Sundry Print Report

Well Name: RED HILLS UNIT	**Well Location:** T25S / R33E / SEC 33 / NENE /	**County or Parish/State:**
Well Number: 79H	**Type of Well:** OIL WELL	**Allottee or Tribe Name:**
Lease Number: NMNM005792	**Unit or CA Name:**	**Unit or CA Number:**
US Well Number: 3002551928	**Well Status:** Approved Application for Permit to Drill	**Operator:** CIMAREX ENERGY COMPANY

Sundry ID: 2768269

Type of Action: APD Change

WELL LOCATION AND ACREAGE DEDICATION PLAT

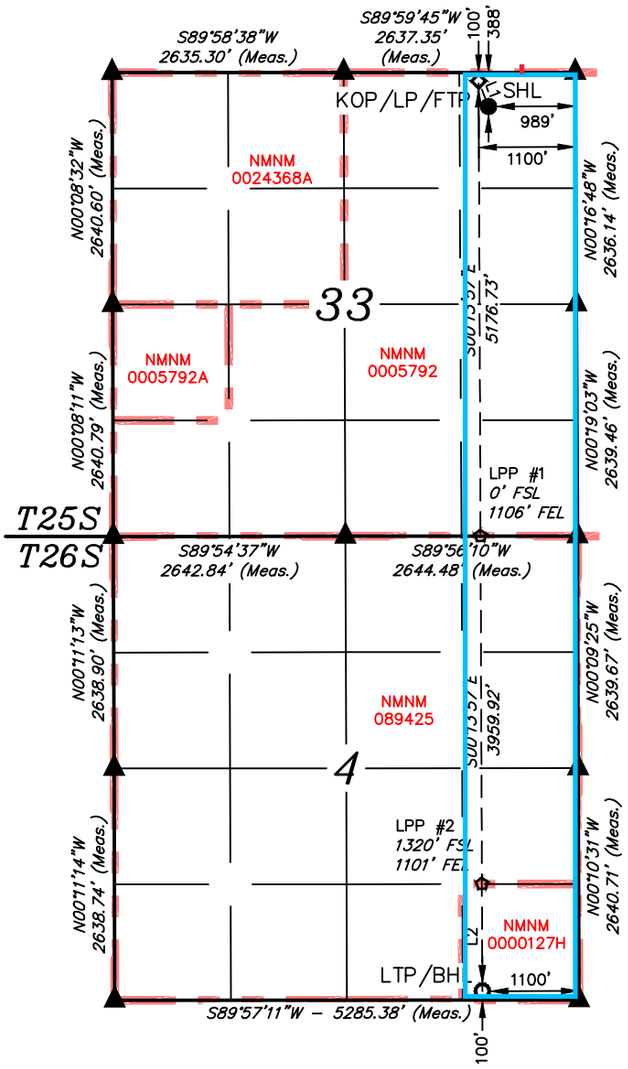
Procedure Description: Cimarex Energy Company respectfully requests the following drilling and directional changes be made to the existing and approved APD for the following well: Red Hills Unit 79H 1. Casing design change - Long String to Liner. 2. New bottom hole location. See attached.

Sundry ID	Well Name	API	S/T/R	SHL Old	SHL New	S/T/R	BHL Old	BHL New
	Red Hills Unit 79H	30-025-51928	33/25S/33E	388 FNL 989 FEL	No Change	4/26S/33E	100 FSL 1173 FEL	**100 FSL 1100 FEL**
		TVD Old	**TVD New**	**MD Old**	**MD New**	**Old Formation**	**New Formation**	**Producing Zone**
		10,750'	**10,404'**	20,620	**20,330**	Wolfcamp	**2nd Shale**	**WC G-09 S253335K;LOWER BONE SPRING**

UL or lot no.	Section	Township	Range	Lot Idn	Feet from the	North/South line	Feet from the	East/West line	County
P	4	26S	33E		100	SOUTH	1100	EAST	LEA

Drilling 12 1/4” hole below 13 3/8” Casing

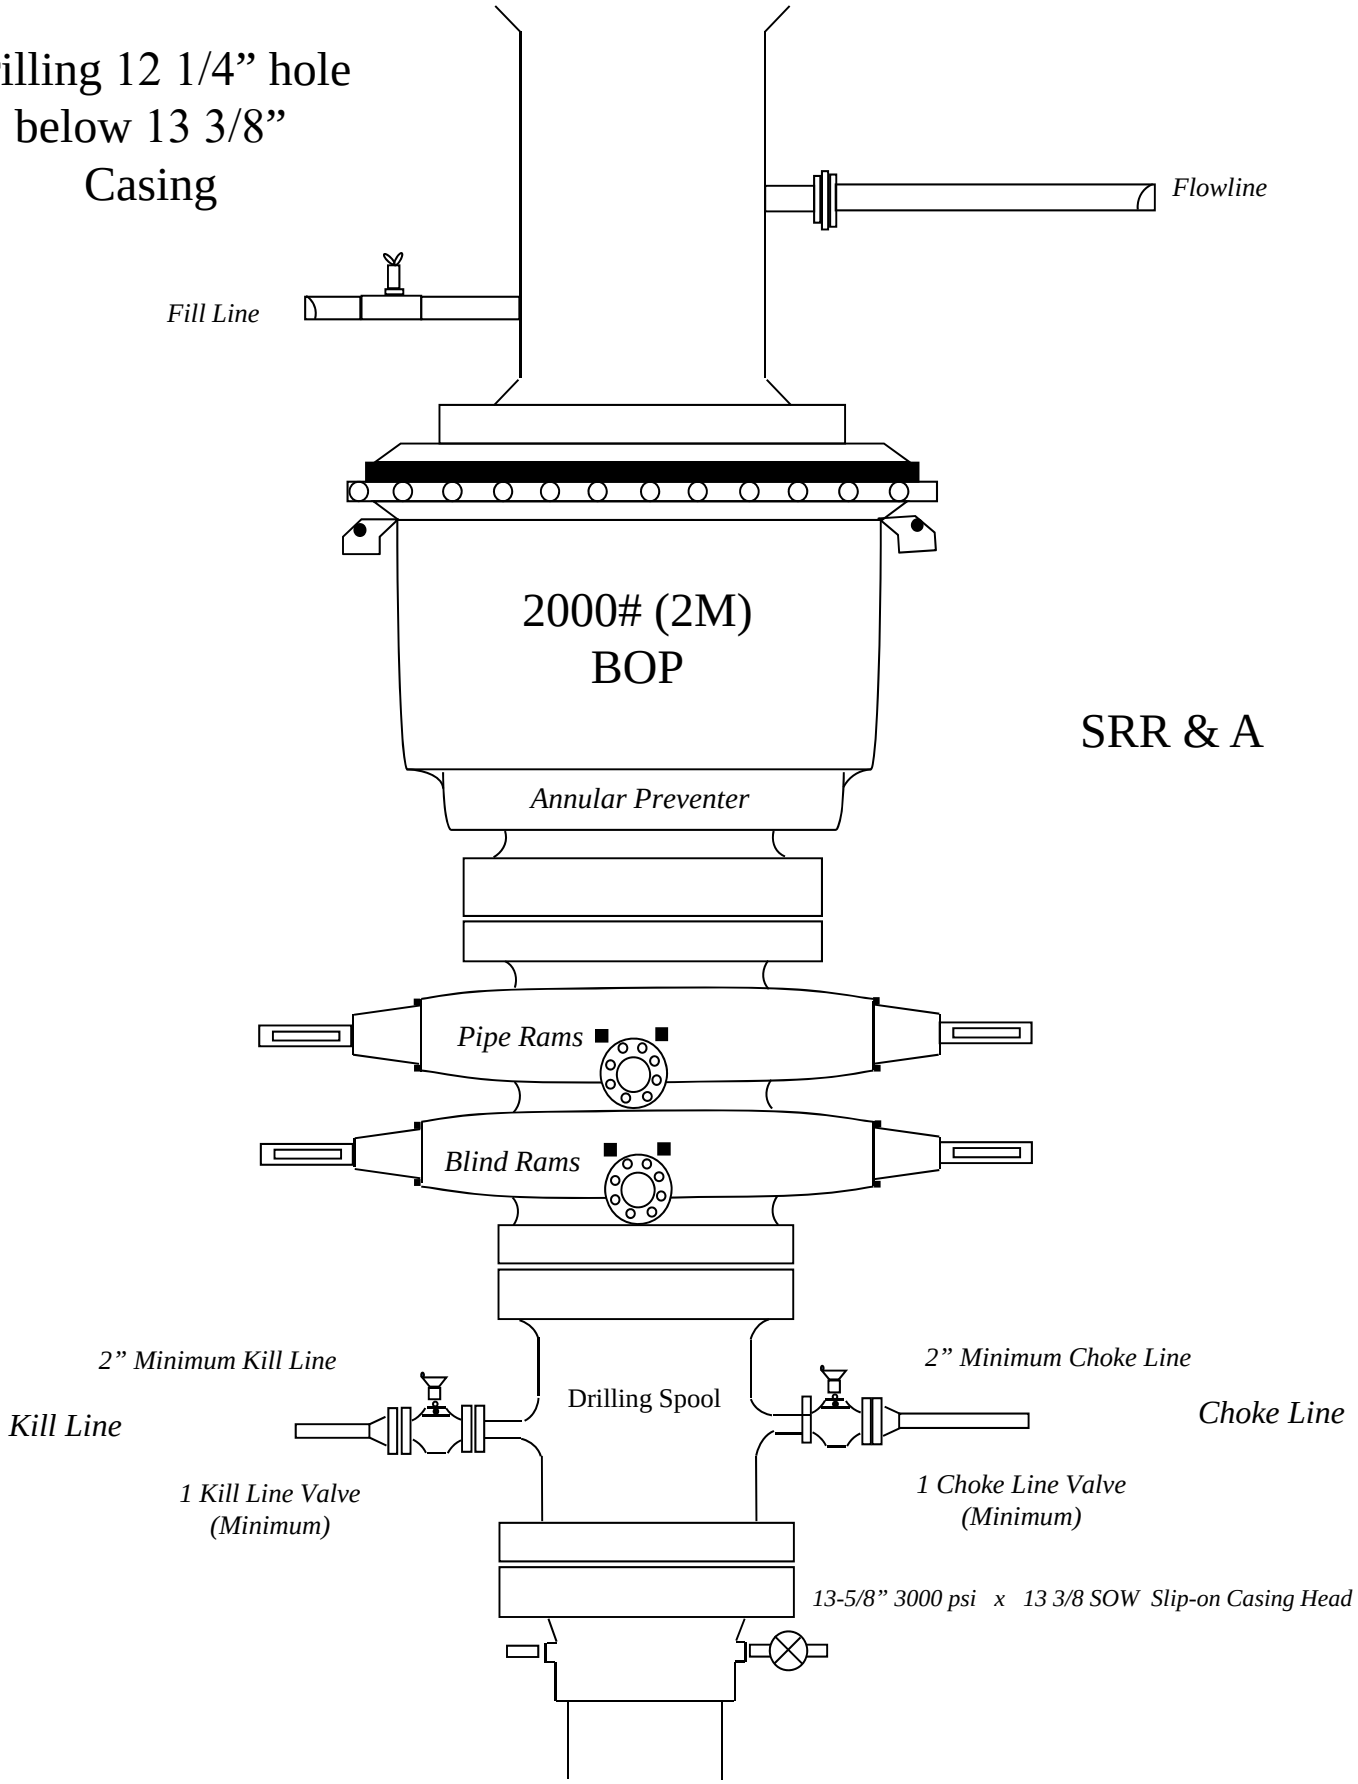
Section 2 - Blowout Prevention	
Old	New
2M	**2M**
5M	**3M**
	5M
